From: **Michael Law** Michael.Law@beca.com  
Subject: RE: Pinehaven Stream hydrology - Existing and Future Development  
Date: 11 June 2015 at 5:05 PM  
To: Kristin Stokes Kristin.Stokes@mwhglobal.com  
Cc: Mike Harkness Mike.Harkness@gw.govt.nz, Mark Hooker Mark.Hooker@gw.govt.nz

**From:** Michael Law  
**Sent:** Wednesday, 27 May 2015 12:29 p.m.  
**To:** [Kristin.stokes@mwhglobal.com](mailto:Kristin.stokes@mwhglobal.com)  
**Cc:** Mark Hooker ([Mark.Hooker@gw.govt.nz](mailto:Mark.Hooker@gw.govt.nz))  
**Subject:** Pinehaven Stream hydrology - Existing and Future Development

Extract from draft report prior to review

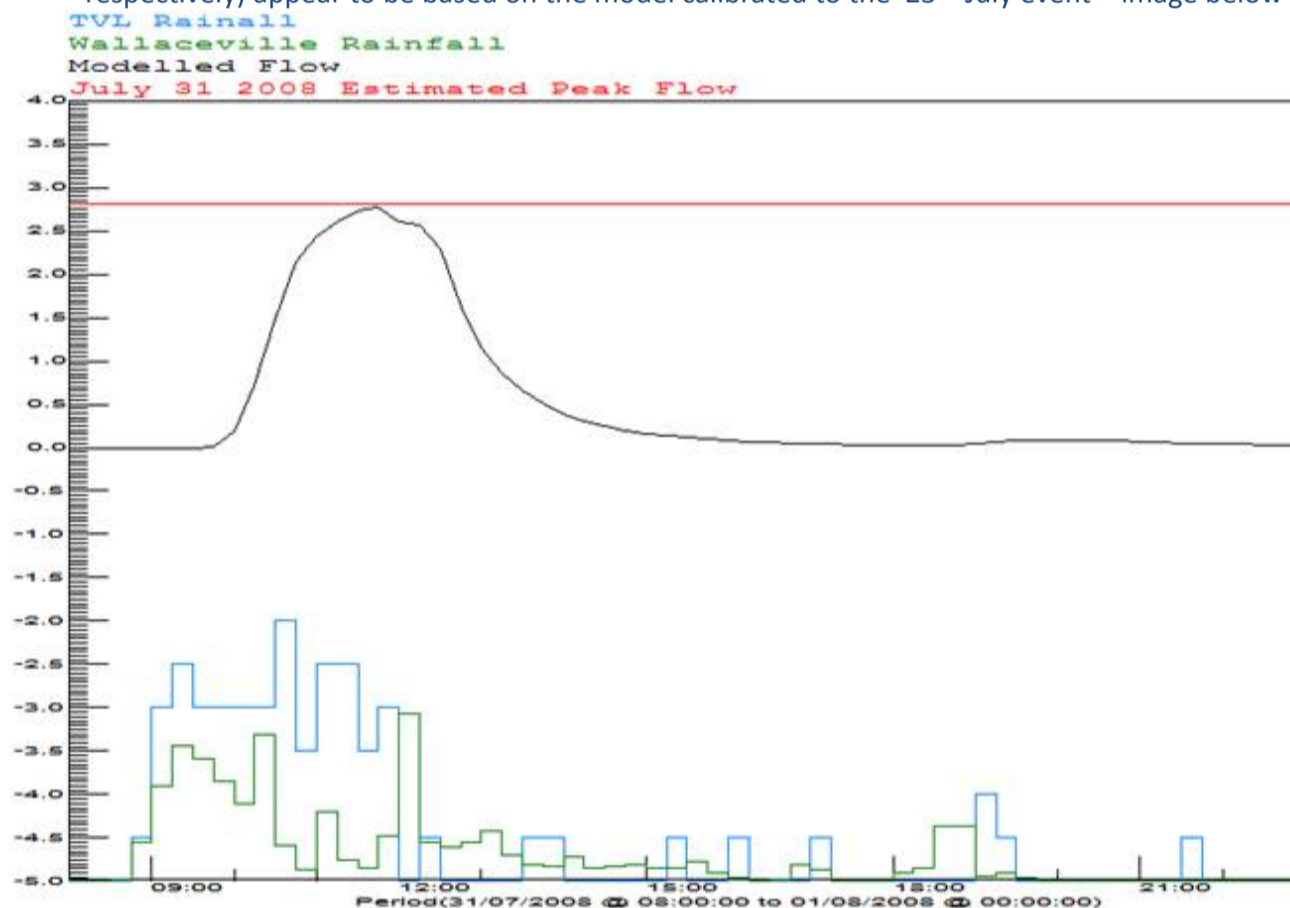
The new alpha and N values given in the appendix B, Revision of our report ( 2 and 1.7 respectively) appear to be based on the model calibrated to the 23<sup>rd</sup> July event – image below

Figure 8.1 – Existing and maximum probable development hydrographs

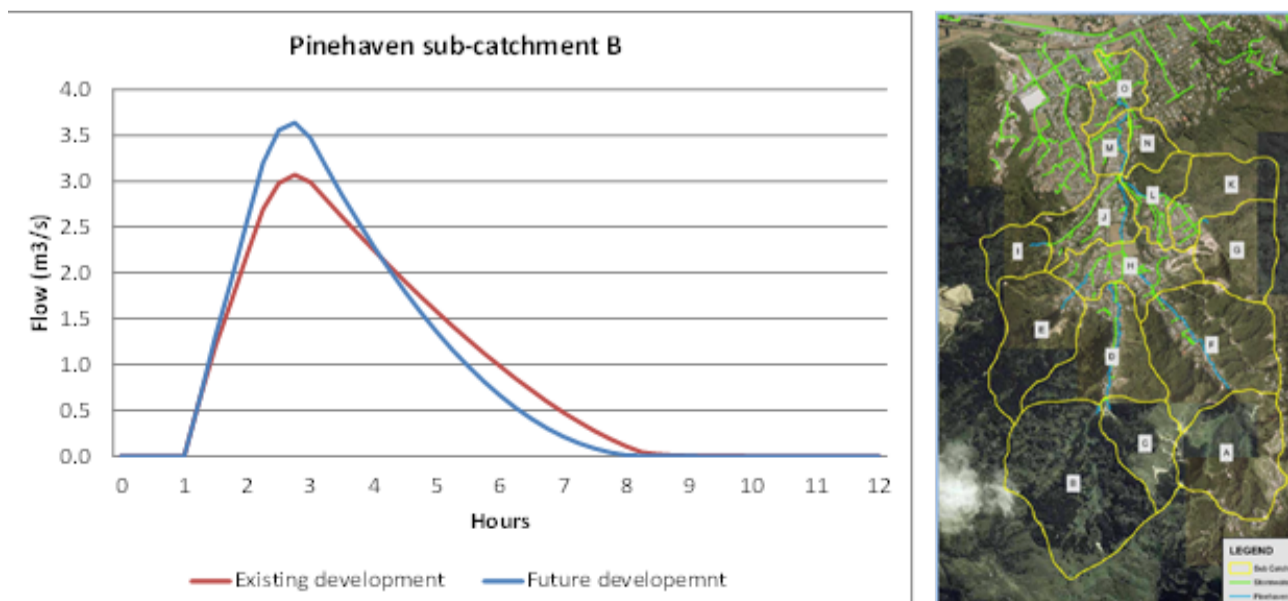
Figure 8.1 shows the change in flood hydrographs for existing development (*E4\_Q100CC\_2hr\_HB.bnd11*) and future development (*E4\_Q100CC\_FP\_2hr\_HB.bnd11*) for sub-catchment B, which is in the southwest of the catchment and drains to the top of Pinehaven Road.

Future development increases the peak flow by 18% (from 307m<sup>3</sup>/s to 3.64m<sup>3</sup>/s), and the flow recession is steeper than for the existing land use. However, the flood volume does not increase. This

is unexpected, as increasing the impervious area of sub-catchment by 40% to reflect the development would be expected to reduce rainfall losses and increase runoff volume. Similar results were found for sub-catchment E, which drains to Wyndham Road.

Assuming a 100-year ARI plus climate change rainfall depth of 87.1mm for the 3-hour storm, an Initial Loss of 5mm, Ongoing Loss of 2mm, and 40% impermeable area for the affected post-development sub-catchments, then the effective rainfall depths would be;

- 76.7mm (88%) for existing land use
- 80.8mm (93%) for post-development land use

The difference between existing and post-development flood volumes would be expected to be to a similar ratio. The existing ground cover of bush and pine forest on sloping catchments generated relatively high runoff, when compared to natural vegetation on flatter ground. This is reflected in the 88% effective rainfall for the existing situation and only 5.6% increase in effective rainfall post-development.

Thnaks for getting back to me. If the initial and continuing losses are the same in both models, then the flood volumes will be the same (so long as there isn't another % impermeable area parameter that negates the losses). So that could explain the volumes. Other parameters within the model could possibly speed up the runoff response to reflect that aspect of development.

As far as we can tell the initial Loss and continuing losses used are the same in both models (5mm and 2mm).

The Hydrol model doesn't take any further excess out apart from the initial and continuing losses so that could explain why the volume is the same.
